PERMIT

SEWAGE DISPOSAL SYSTEM

MARYLAND STATE DEPARTMENT OF HEALTH

FILE: Sewage Odor Nuisance

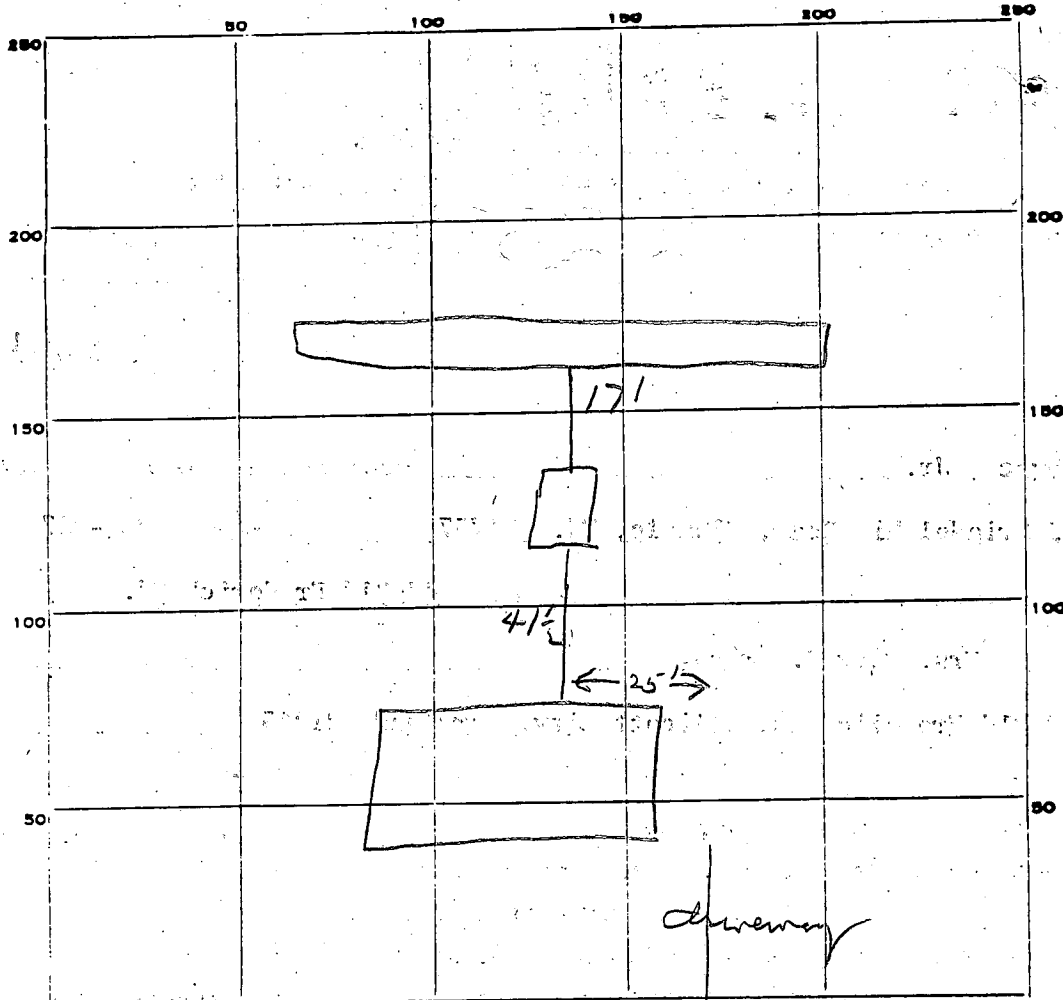
REPAIR - Call for inspection when ground is opened up so sanitarian can recommend repair.

New system - 1000 gal tanks, 50 ft trenches
1 1/2 ft deep, inlets 4 ft, 7 1/2 ft of stone

REMARKS 12/8/81 OK to add stone in trench. js
12/8/81 OK to cover all work js

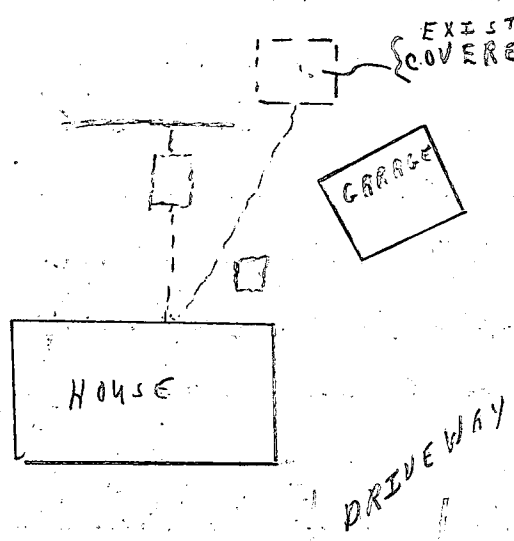
VENT TO TOP OR SIDE

NEW BLOCK FOUNDATION

EXISTING COVERED HOLDING TANK } RECOMMEND NOT AIR TIGHT

- (1) WORK START TO PUT ANOTHER LAYER OF BLOCK AROUND LID & DR ROOF TO MAKE IT AIR TIGHT WITH A VENT. (SEE ABOVE)
- (2) SCREEN AREA WITH PINE TREES
- (3) CHECK ^{NOT AVAILABLE} _{1/25/81} PUBLIC SEWER AVAILABILITY
- (4) RECALL 12/23/81 AND CHECK PROGRESS. & OR FOR OVERFLOW OF SEWAGE
{ NOTE PIT 1'-2' FROM TOP - 11/23/81 c.b.d.
